City of Portland, Maine – Building or Use Permit Application 389 Congress Street, 04101, Tel: (207) 874-8703, FAX: 874-8716

REASON FOR PERMIT: Single Family dwelling with attached garage

**CITY OF PORTLAND, ME
BOCA 1990 Plan Review Record
One and Two Family Dwelling**

Building Description: Single Family dwelling with attached garage.

FIRST FLOOR PLAN
 SCALE 1/4" = 1'-0"

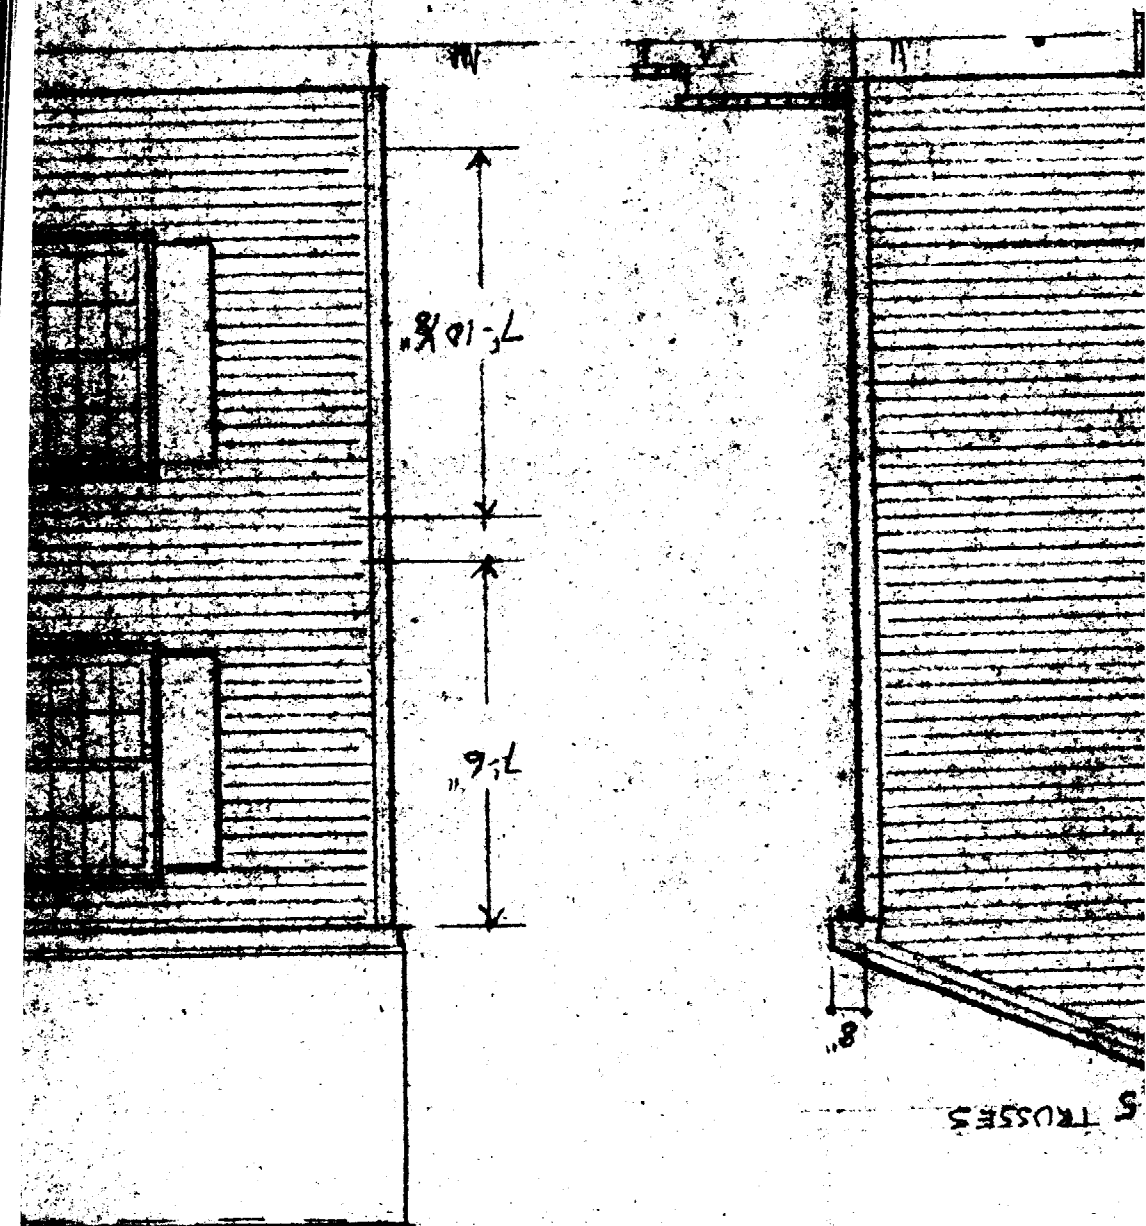
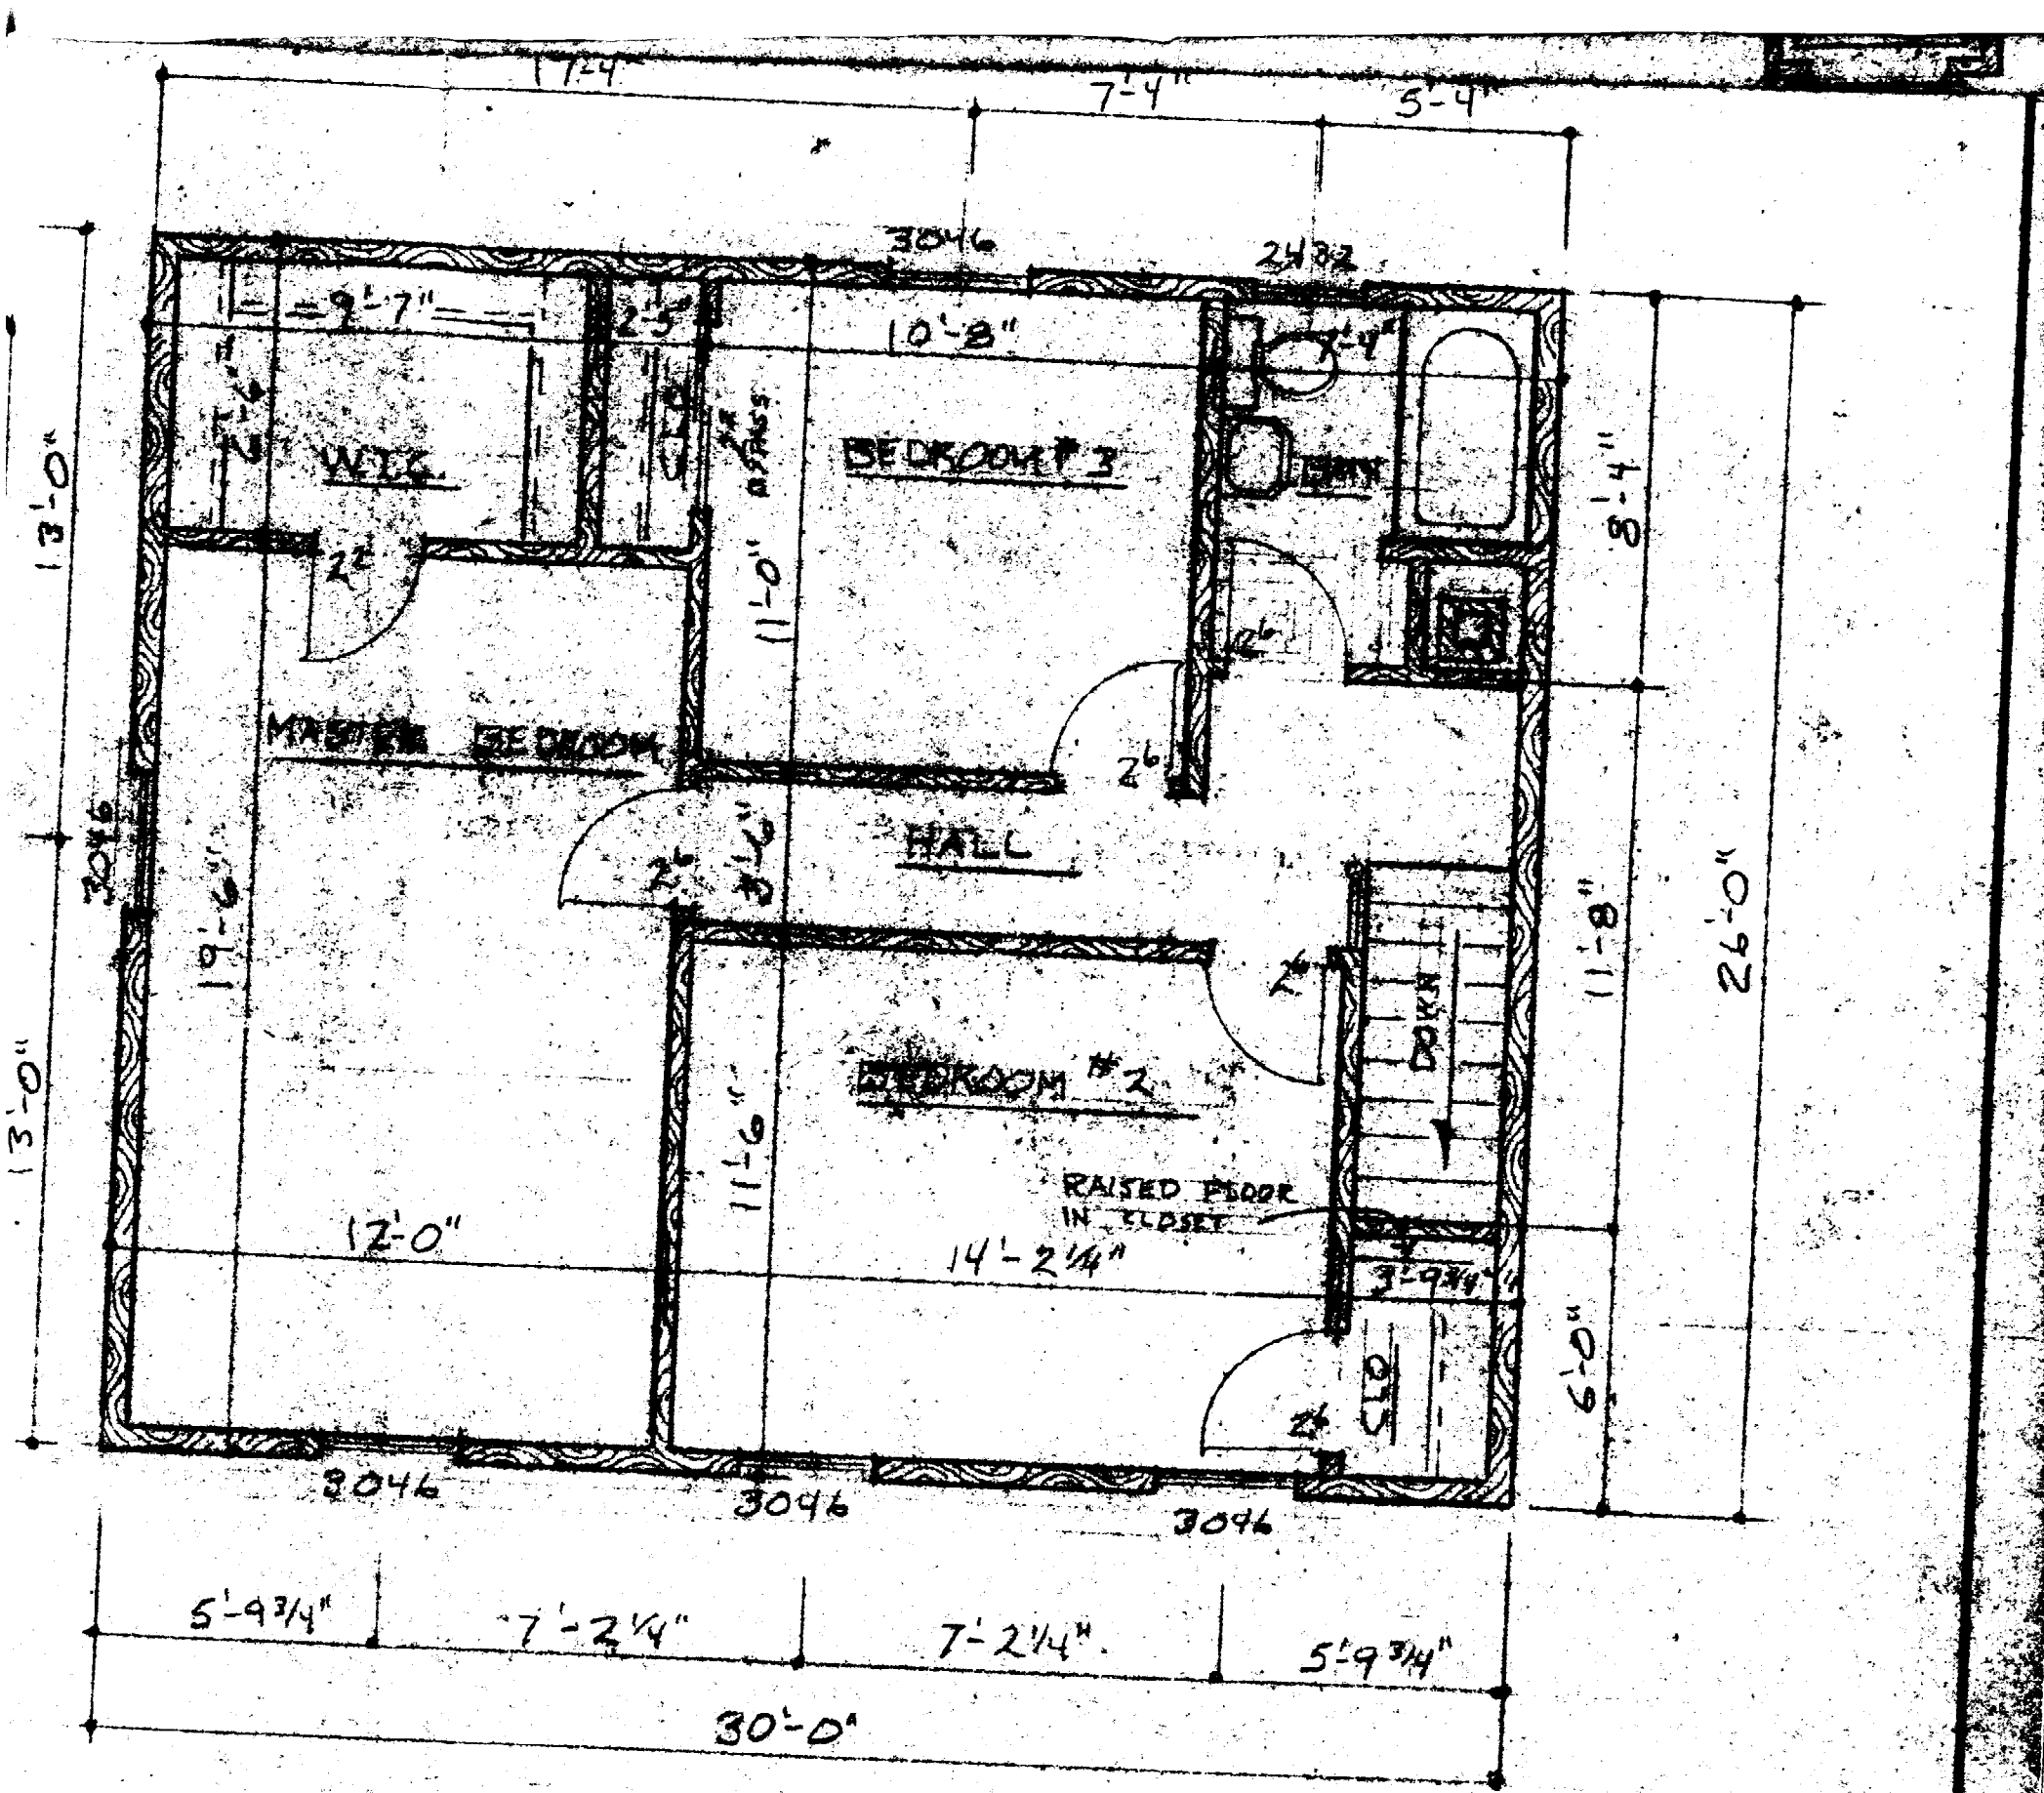
Handwritten
Section 1022.8
